KLINGE CORPORATION

TECHNICAL SERVICE BULLETIN

Subject: Return Probe Location	Bulletin No: 060619
	Last Issued: June 19, 2006

Regarding: New location of thermostat Probes for Improved Defrosts

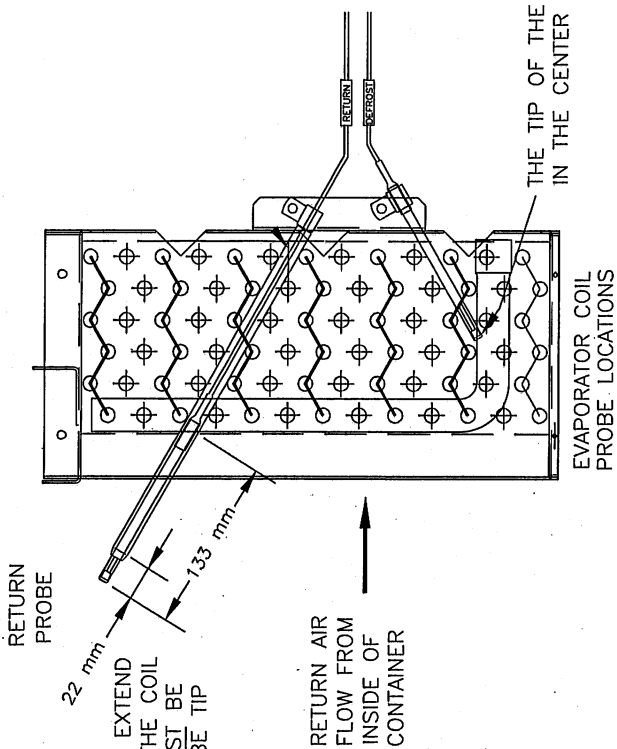
1. The thermostat return probe and discharge probe locations have been changed as shown below.

This change along with the thermostat change to K31-00871-10, ensures a complete defrost and clean coil.

EVAPORATOR VIEW

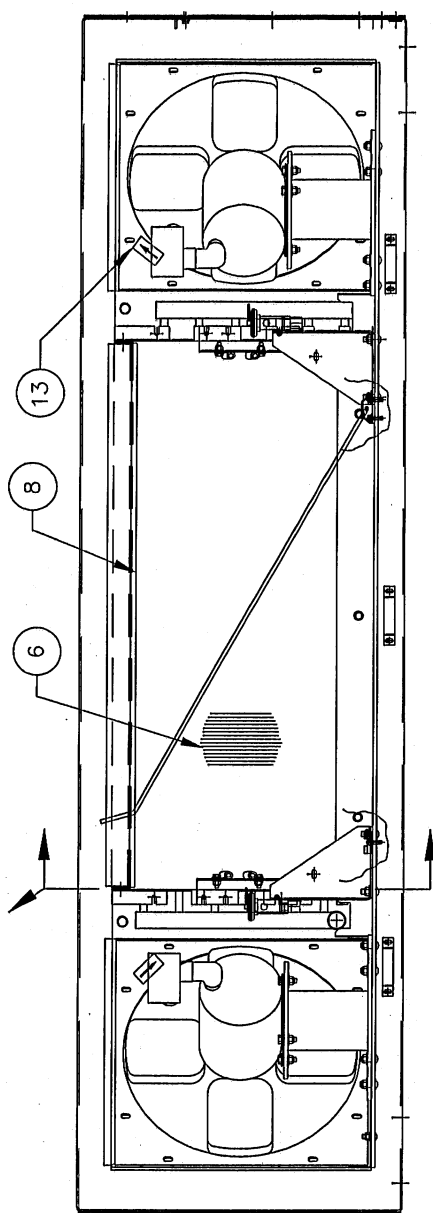
THE TIP OF THIS PROBE MUST EXTEND 133 mm FROM THE FINS OF THE COIL AND THE INSULATING TUBE MUST BE 22 mm BACK FROM THE PROBE TIP FOR PROPER UNIT OPERATION

THE TIP OF THE DEFROST PROBE MUST BE IN THE CENTER OF THE COIL AS SHOWN
